HAVEN VALLEY PUD DEVELOPMENT / PRELIMINARY PLAN

TRACT MAP, LOT TYPICALS & ADJACENT PROPERTY OWNERS

PUD PRELIMINARY
 SITE PLAN

PUD Development Plan - _v4.pdf Markup Summary 5-9-2022

COVER SHEET

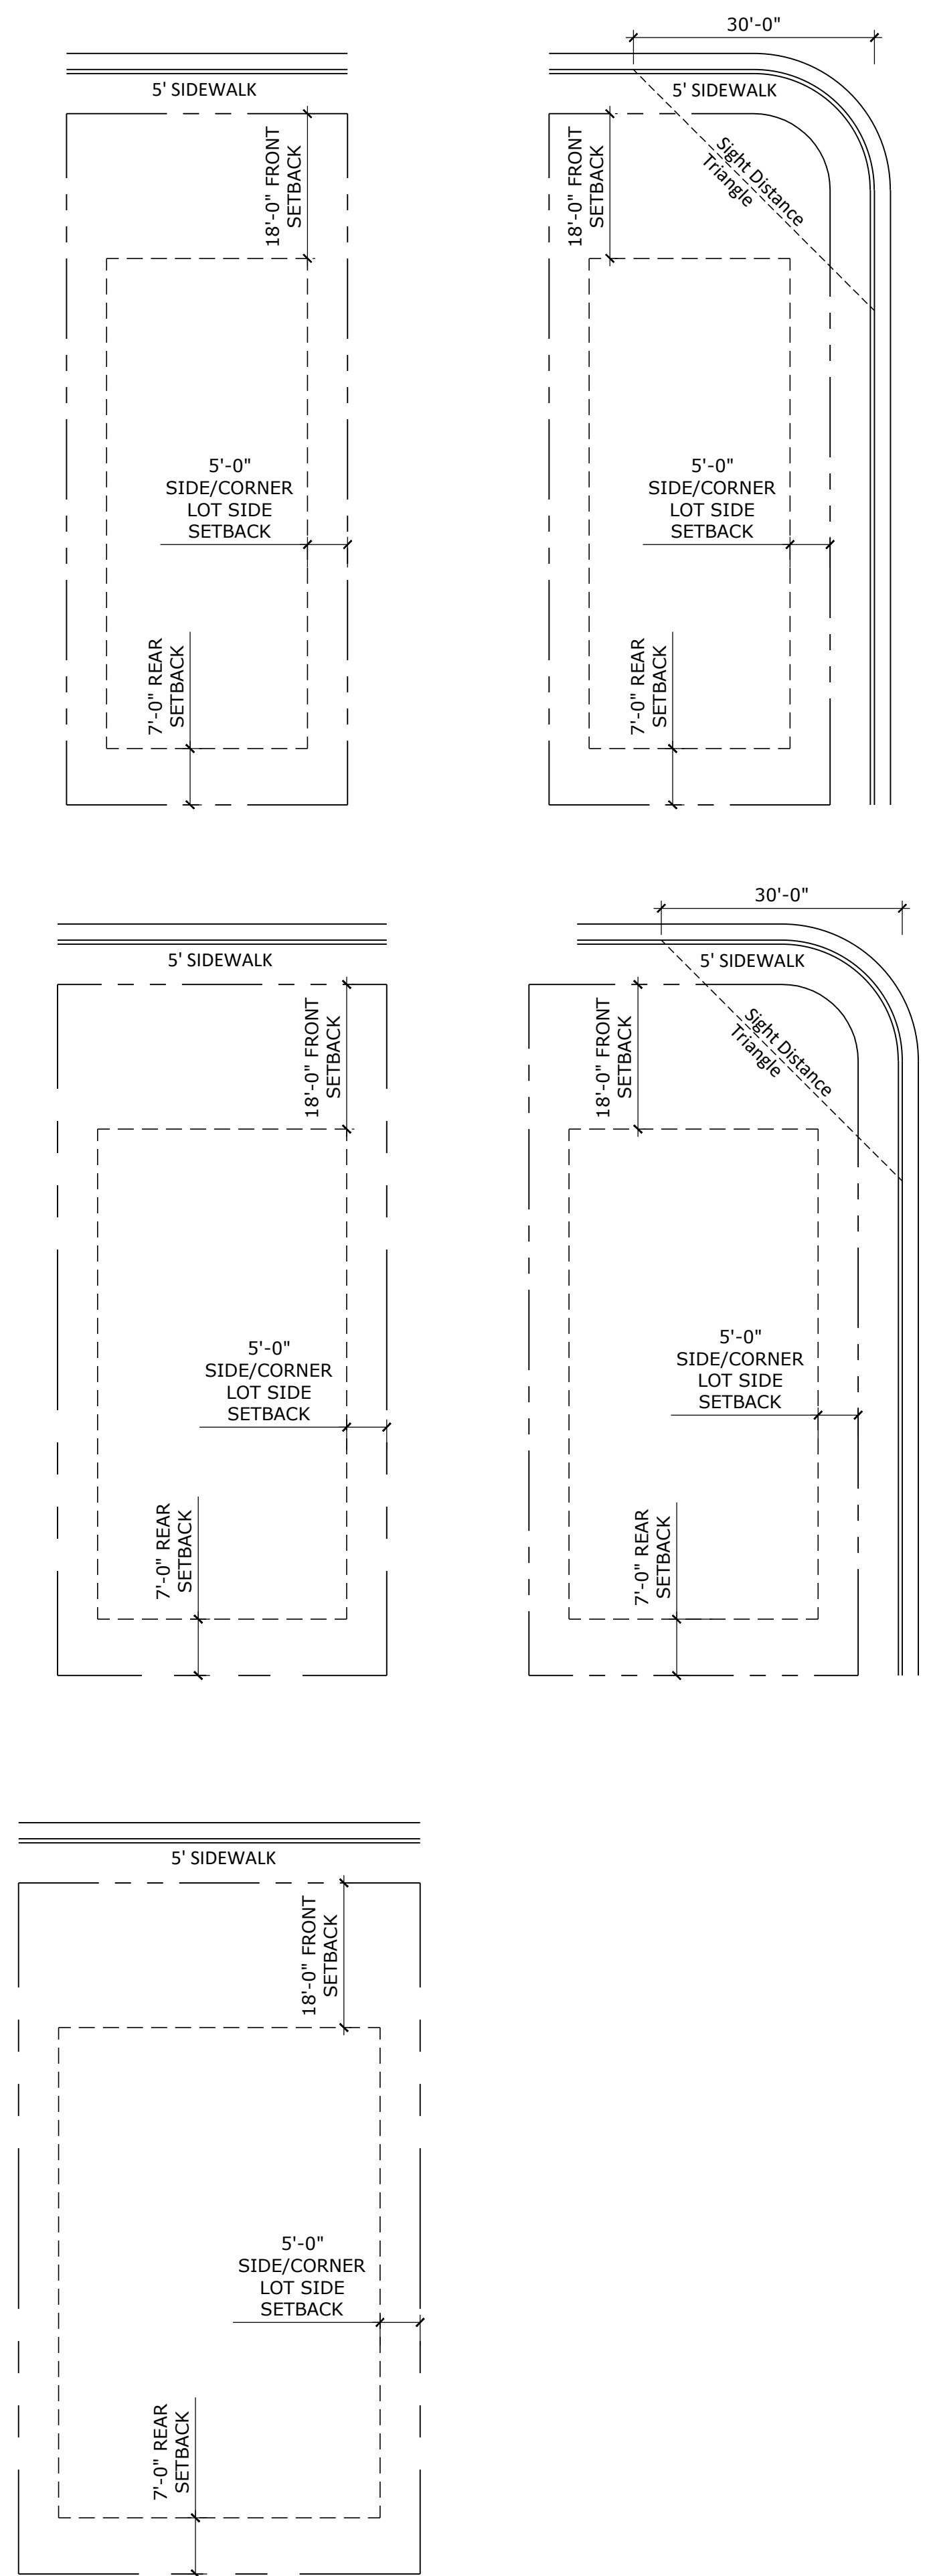
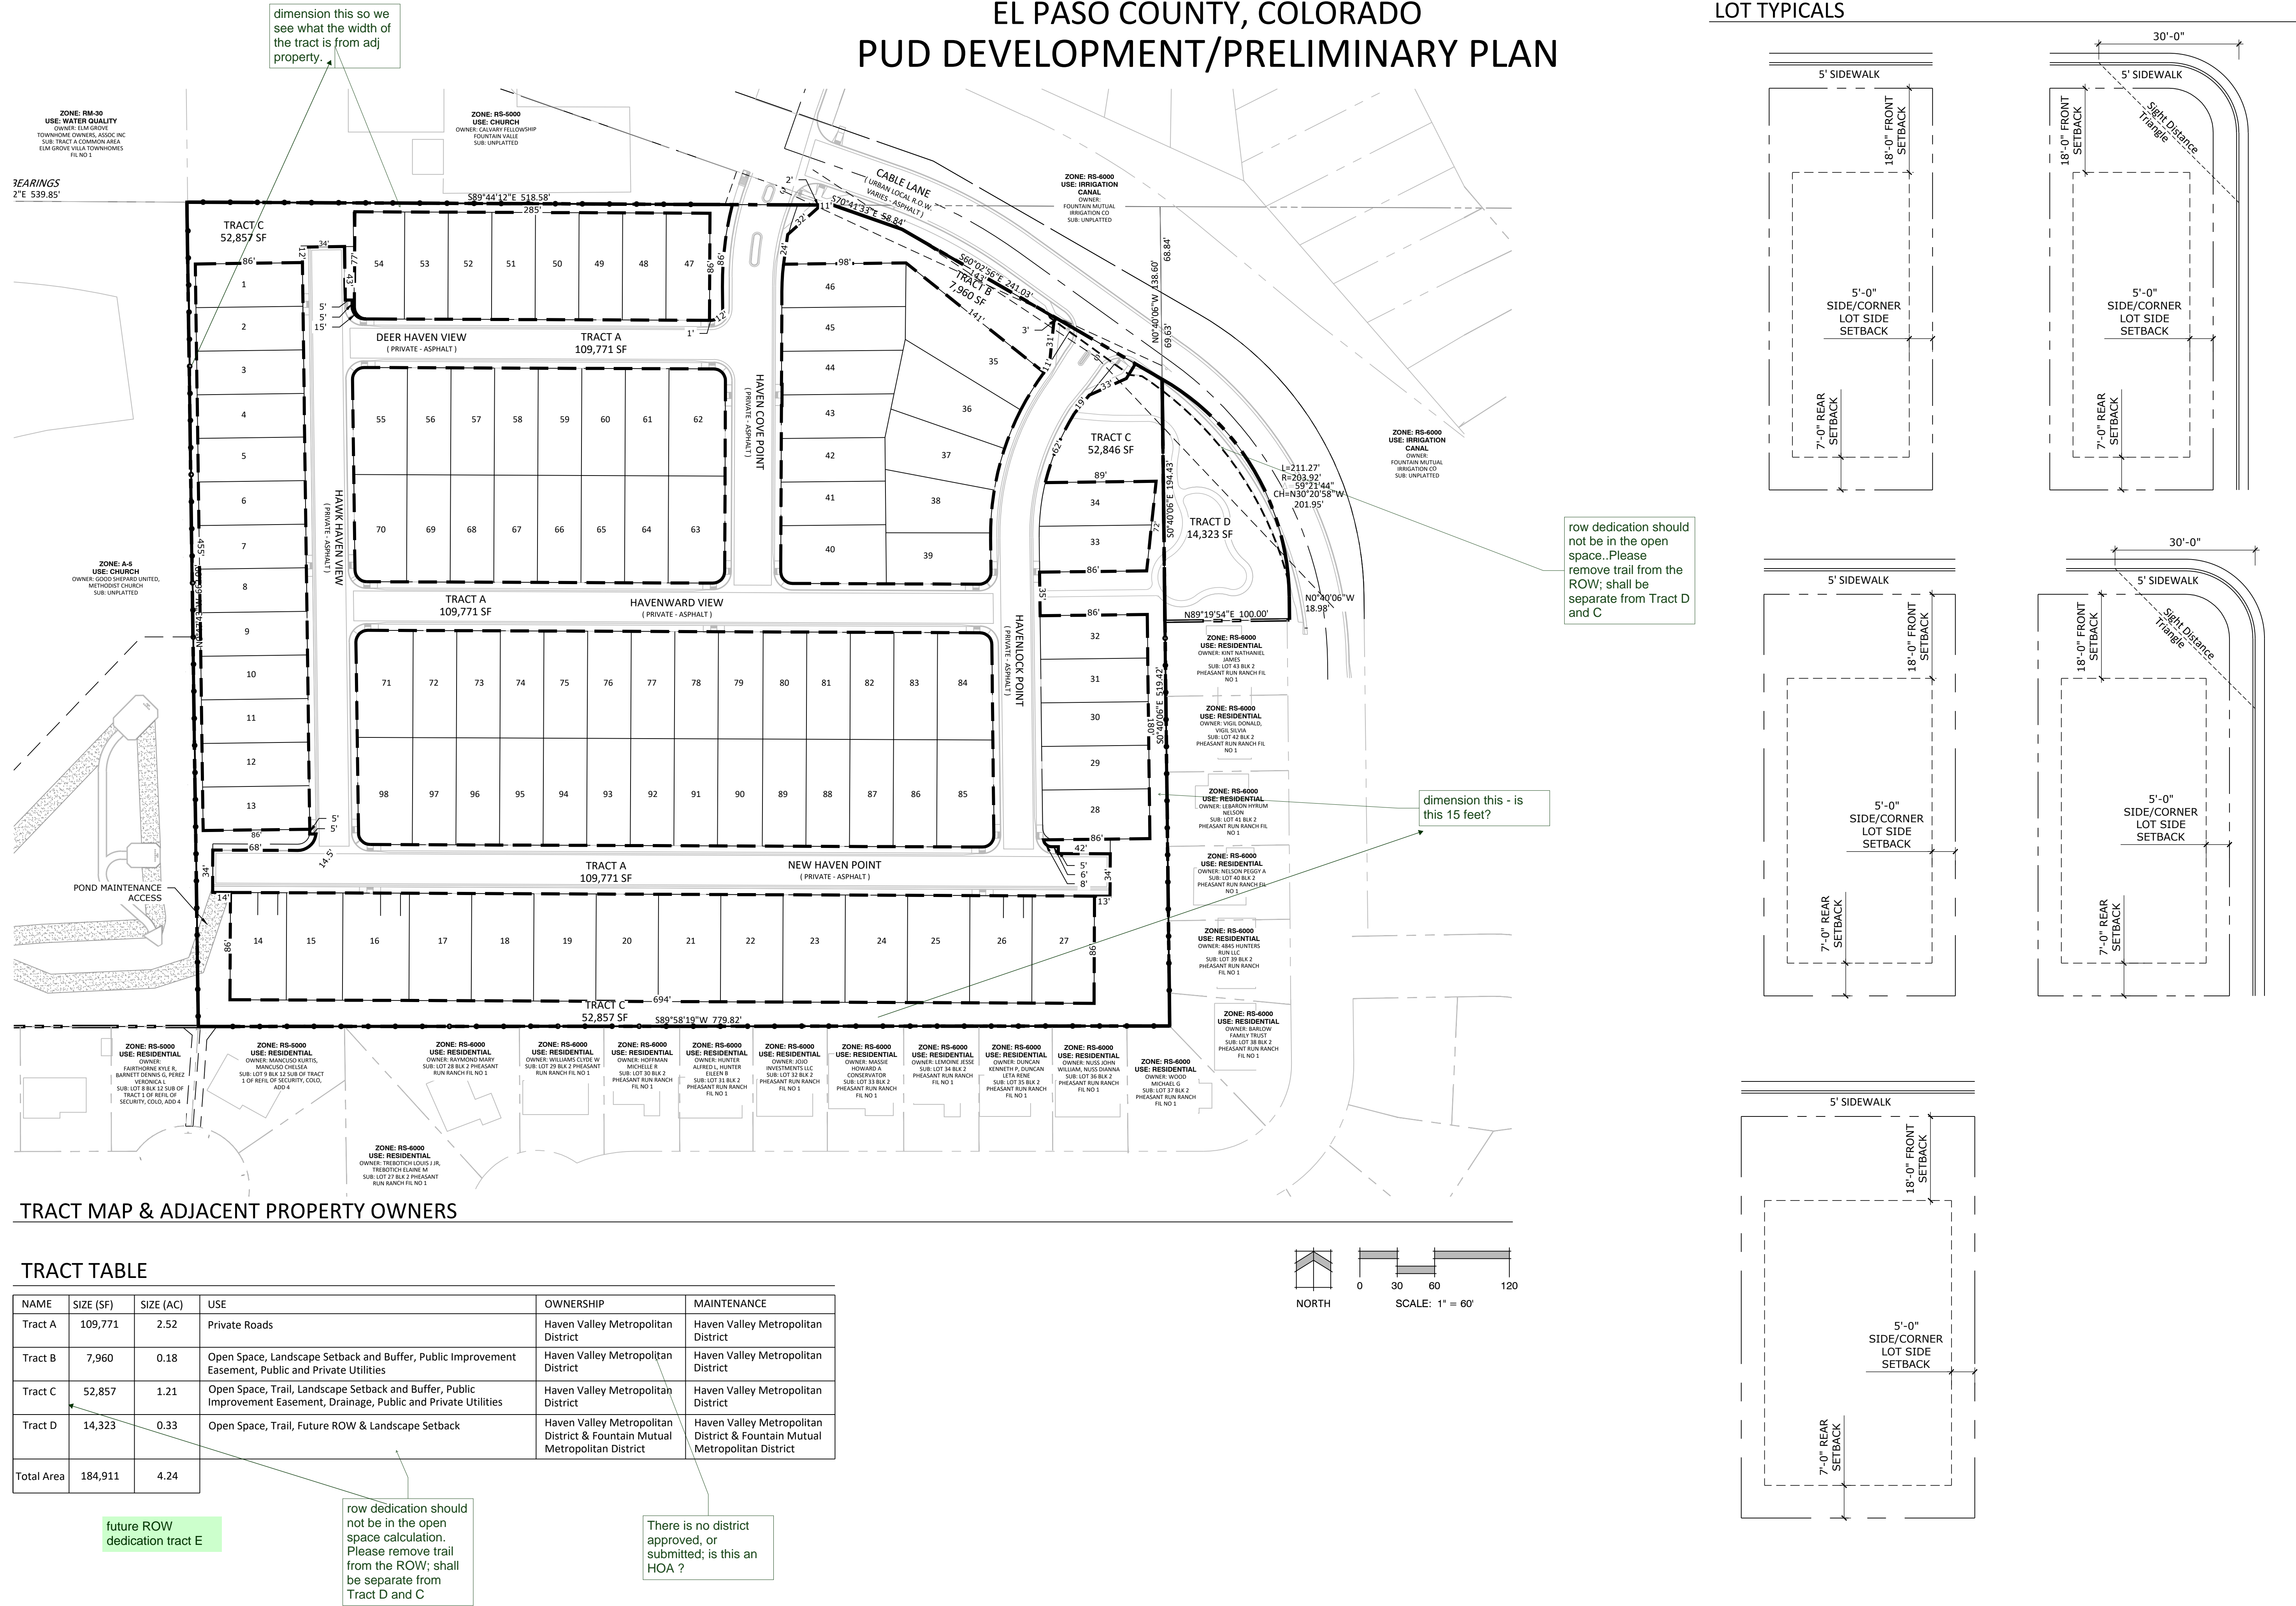
HOA or metro district per next sheet. Please address.

Add no basement note please.

of that what is usable (25% required)

tract table states 4.24AC

Future ROW tract

I thought this was detached homes per elevations/LOI

Verify that the owner is correct upon resubmittal

ADD Note to the general Notes ; that elevations are conceptual and may change with out a PUD amendment; HOWEVER they must be SF attached homes

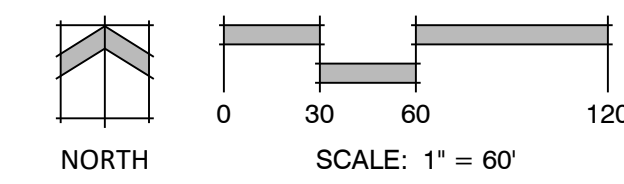
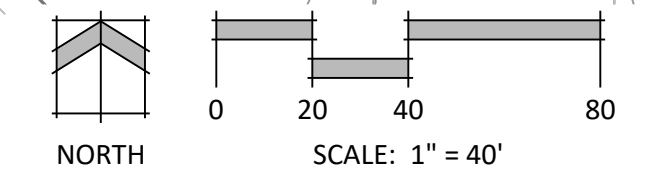
future ROW dedication tract E

row dedication should not be in the open space calculation. Please remove trail from the ROW; shall be separate from Tract D and C

There is no district approved, or submitted; is this an HOA ?

dimension this so we see what the width of the tract is from adj property.

dimension this - is this 15 feet?

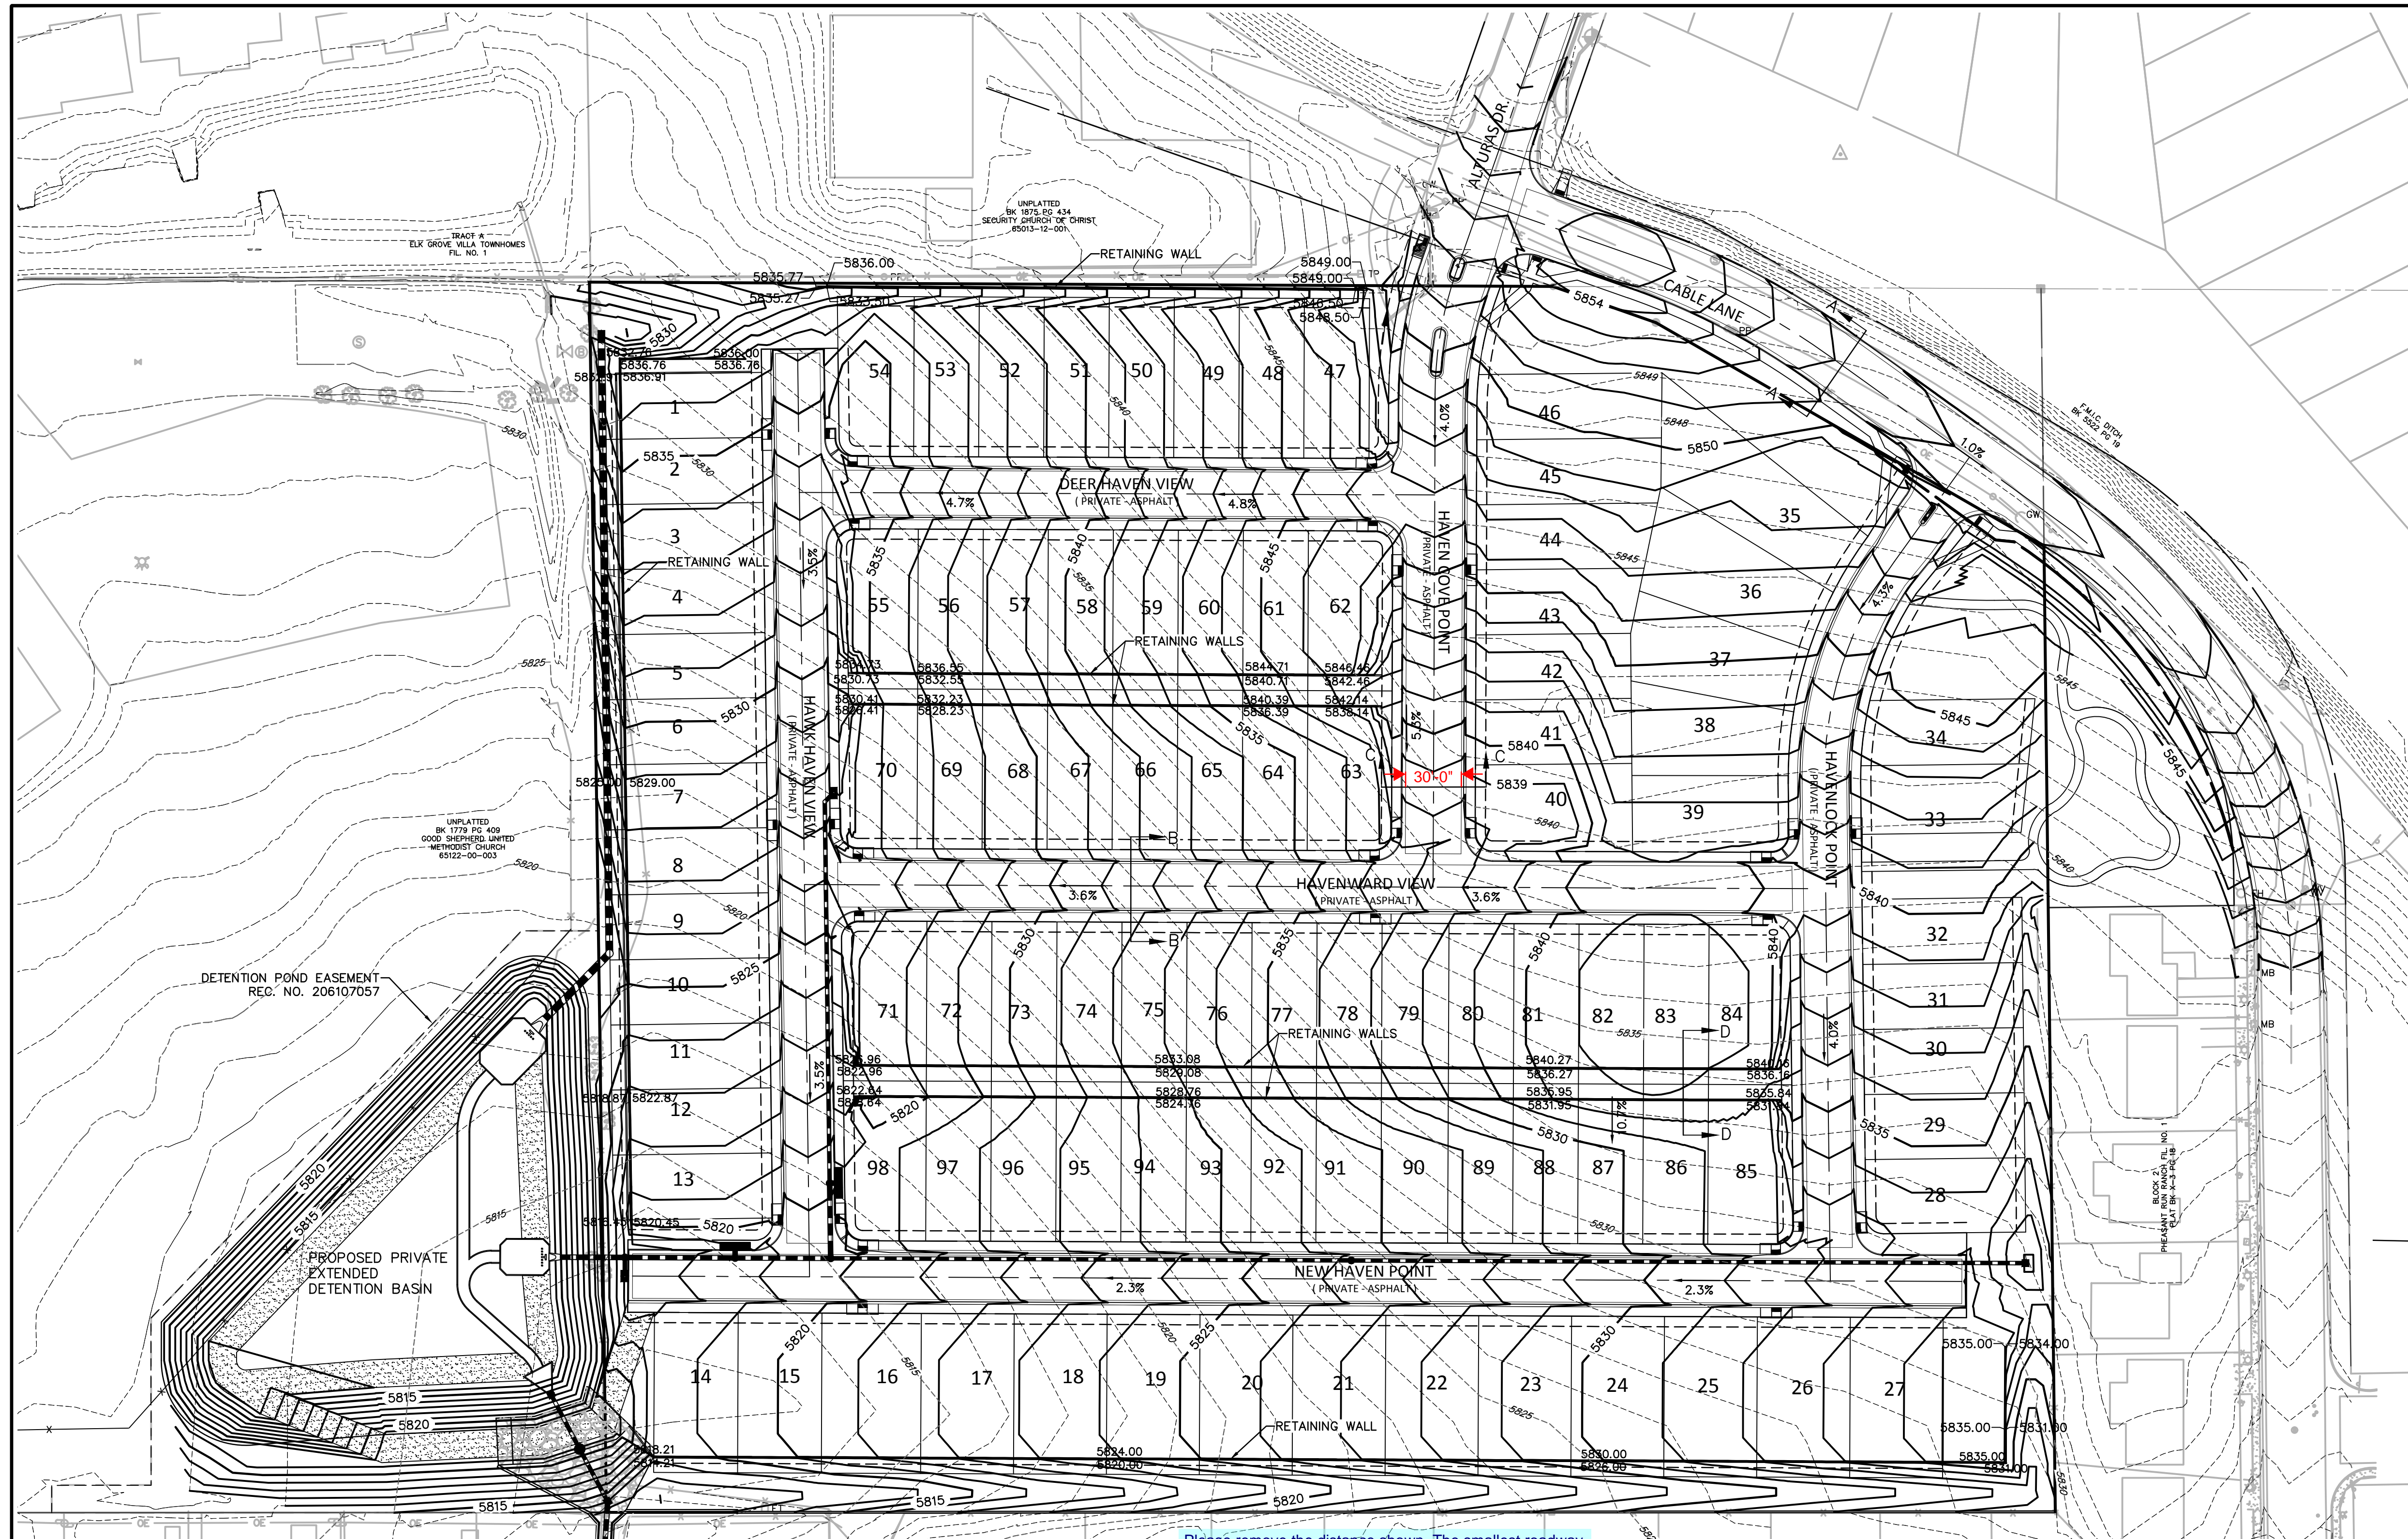
Are these lot lines in the 15'-buffer? That would not meet the 15' buffer. Request a PUD Mod for a reduced buffer of X where 15 feet is required and identify which BOCC criteria to justify...

Are these ROWs 29' or 35', 39' please label the row for the private roads; its difficult to see lot lines (I assume sidewalks are in ROW not lots)

are these rear lot lines?

label the row widths please

5' sidewalk (label) all walkways

width please
